Re: Docket Nos. 50-277  
50-278

Your letter of June 24, 1981, requested additional information with regard to our May 22, 1981, letter on IE Bulletin 80-06, Engineered Safety Feature Reset Controls for Peach Bottom Atomic Power Station Units 2 and 3. Specifically, we were asked to "provide a description of the modifications made to the circuitry of the Traversing In-Core Probe (TIP) nitrogen purge valves and the TIP ball valves."

# TRAVERSING IN-CORE PROBE SYSTEM

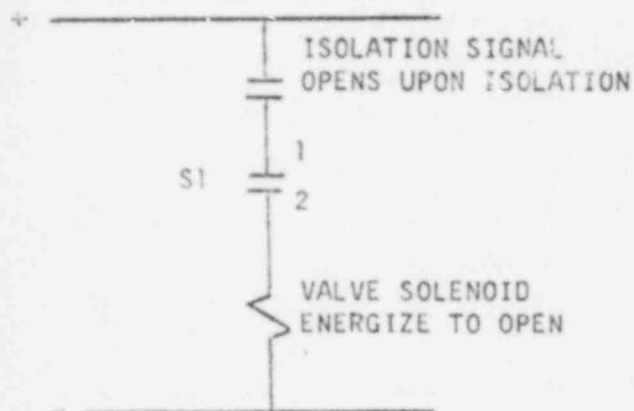
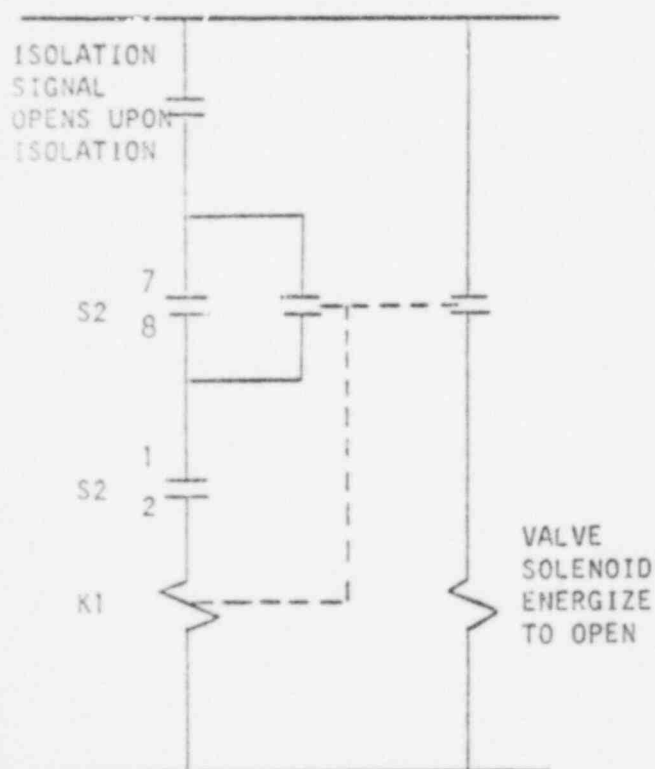
The controls for the TIP purge isolation valve and the five TIP ball valves have been modified by replacing the existing, two-position, maintained-contact control switches with three-position, spring return-to-auto control switches. The control logic has been modified so that the operator must place the control switches in the "open" position before the valves will reopen following the reset of a primary containment isolation signal.

Attached is a drawing showing the circuit and contact development for a two position switch versus a three position spring return to center switch.
